City of Portland, Oregon
Bureau of Development Services
Land Use Services
FROM CONCEPT TO CONSTRUCTION

NOTICE OF A TYPE II DECISION ON A PROPOSAL IN YOUR NEIGHBORHOOD

CASE FILE NUMBER: LU 18-129780 DZM – ROOFTOP MECHANICAL

3RD & TAYLOR / PORTLAND, OR
AERIAL VIEW C.4

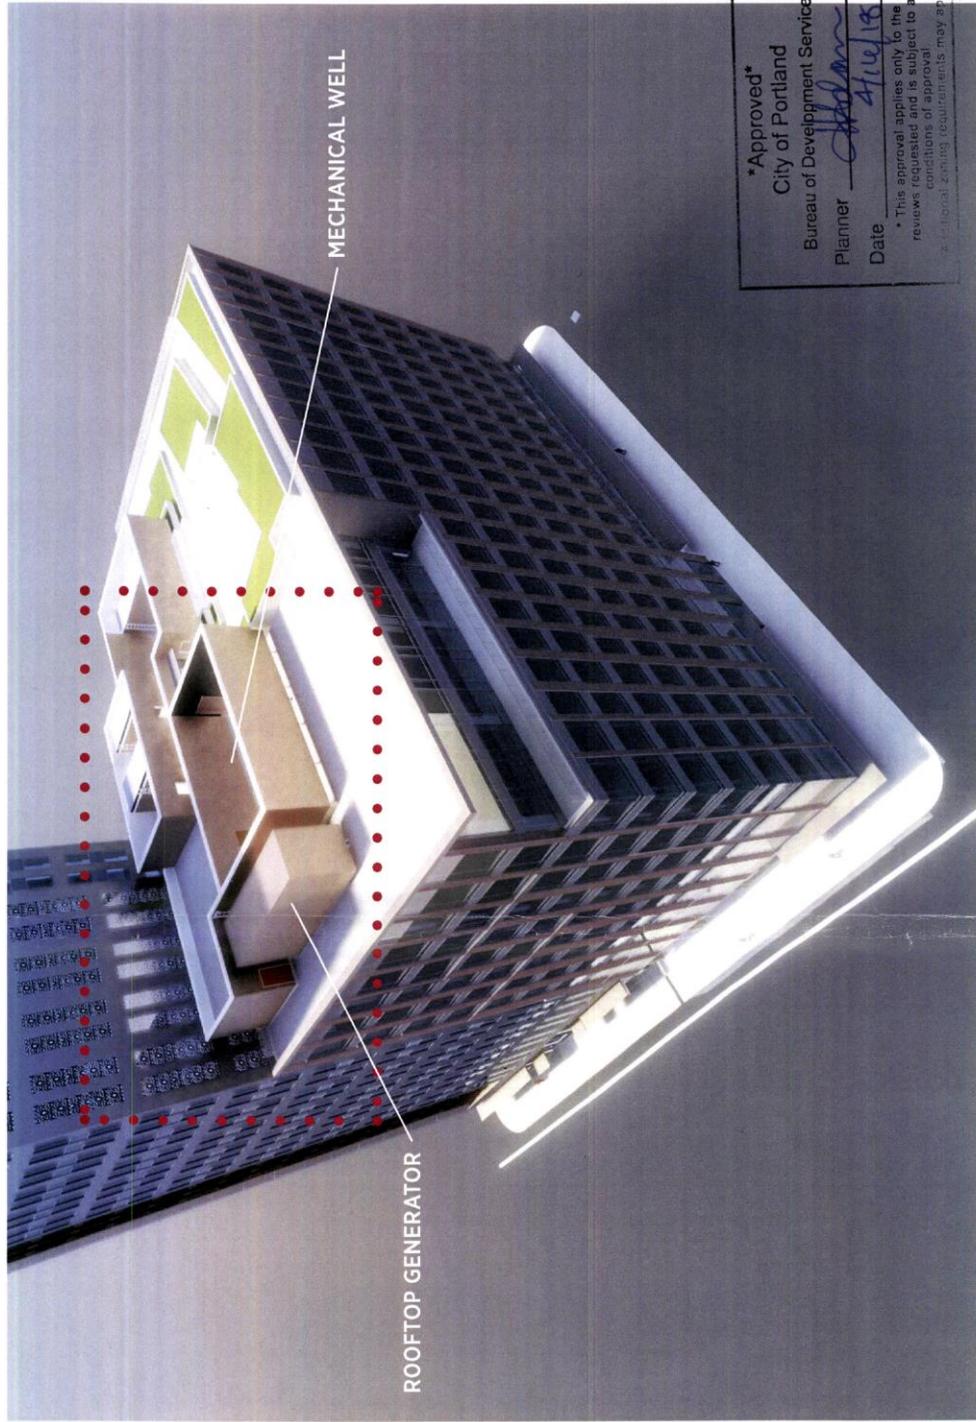
Modification #1: 33.130.210 – to increase the amount of roof area dedicated to mechanical equipment and stair enclosures from 10% to 31.41% and to increase the height of the proposed generator from 10'-0" to 14'-9".

Findings: The revised layout better meets Guideline C5 Design for Coherency in that the generator is now located in a space that seemingly designed for it, effectively serving to close the corner of the notched mechanical enclosure while the previous design featured a generator that was not accounted for in a cohesive manner, but rather located outside and disconnected from the mechanical enclosure. The proposed increased height matches that of other rooftop enclosures forming a more cohesive design.

Findings: The purpose of the height standard is to control the overall scale of buildings while allowing the tallest buildings in this zone, the CX zone. The proposal meets this standard in that the overall height of the building is still controlled while the height and total area dedicated to mechanical uses is relatively minimal and allows the user of the building to meet their mechanical needs.

1. 33.130.210 – to increase the amount of roof area dedicated to mechanical equipment and stair enclosures from 10% to 31.41% and to increase the height of the proposed generator from 10'-0" to 14'-9".
